TECHNICAL SERVICE BULLETIN

REF.: BODY
 NO.: BO005-96
 DATE: APRIL 26, 1996
 MODEL: AVL

AVALON SUNVISOR RATTLE NOISE

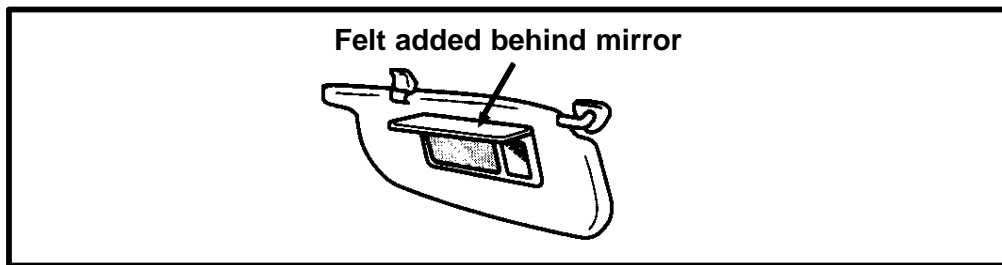
A rattle noise may be heard from the driver and passenger sunvisors on some 1995 Avalons. To eliminate this condition the sunvisor clip opening size has been decreased in production as follows:

Additionally, felt material was added behind the mirror to provide a tighter fit between the mirror and frame.

To correct this condition, remove the original sunvisor clips and replace them with new ones. If the condition still exists, add felt material behind the mirror to prevent rattle noise.
